Title: 17/19DR TERMINAL STRIP LABEL ERROR

Number: C8909  
Date: 6/28/89  
Supersedes: NEW  
Date:

Models Affected: 17/19DR DUAL COMPRESSOR CHILLERS

17/19 DR FIELD WIRING TERMINAL STRIP

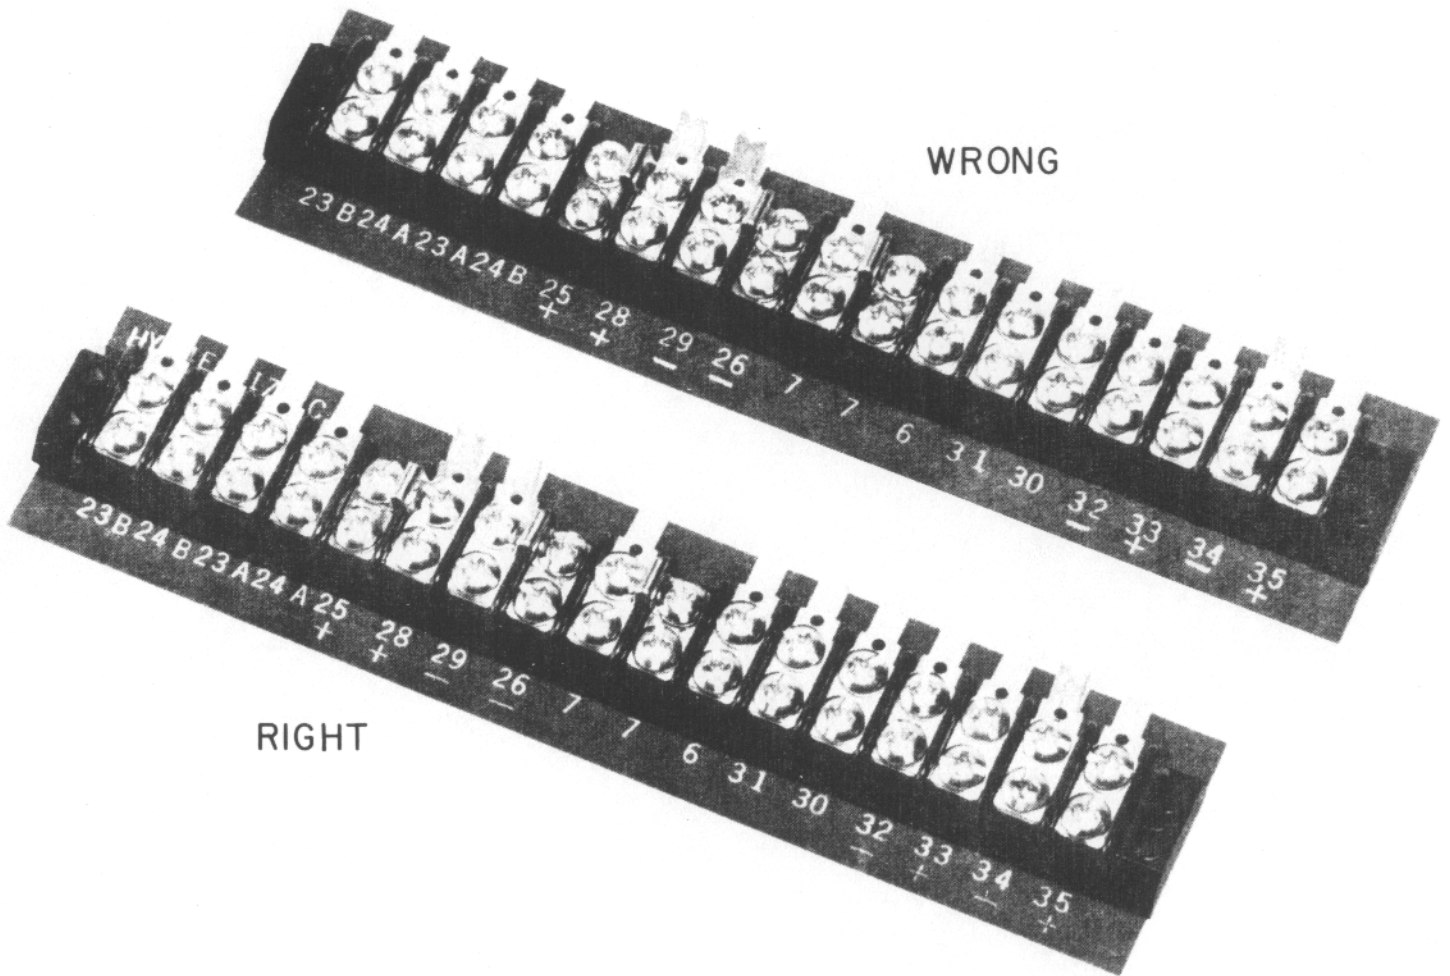
One of the field wiring terminal strips has connections for the 0.5V motor load signal for each compressor motor. An undetermined number of labels with the terminal markings mixed up as shown below have been shipped in chiller control panels. If the field wiring is connected using the wrong labels the compressors will shutdown right after start-up because of a lack of a motor current signal since the factory wiring from the 32MP processor boards was made to the terminals as if they had been marked properly.

WRONG

RIGHT

Check for this label error during start-ups of chillers shipped prior to 6/89. Correct the wrong labels by re-marking and verify that the field wiring is right.
